“JANDY” CARETKER 5 PORT VALVE

OLD PART # 5-9-2000 NEW PART # 5-9-2200

Frequently Asked Questions

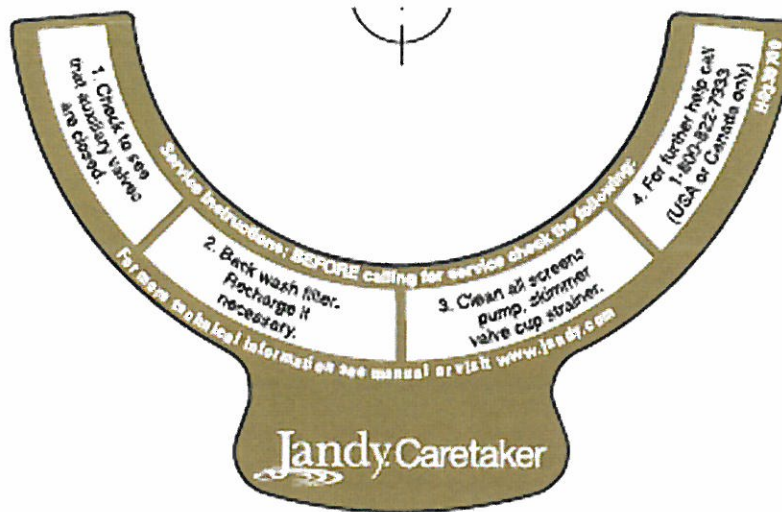
QUESTION: How can I visually identify the new valve?

ANSWER: The label on the “new” valve housing will be **gold** & say “Jandy Caretaker.” The old valve will have a **red** label that says “Polaris Caretaker.” The pressure gauge logo will be changed to “Jandy” as well. See attached photos.

New – Gold Label (Oct. 2009): 5-9-2200

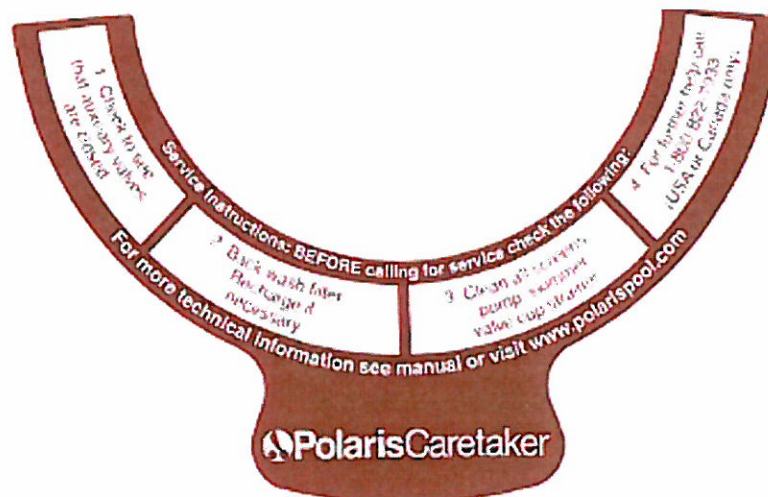
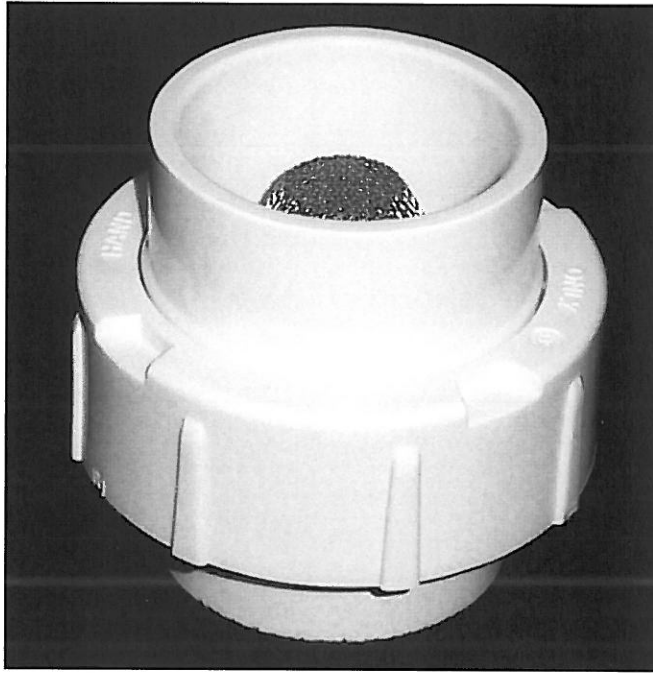
New (Oct. 2009): 5-9-2200 (Text = Hand Tighten Only – A0578901)

Previous: 5-9-2000 (Text = Polaris – PVC Union – 800 8227933)
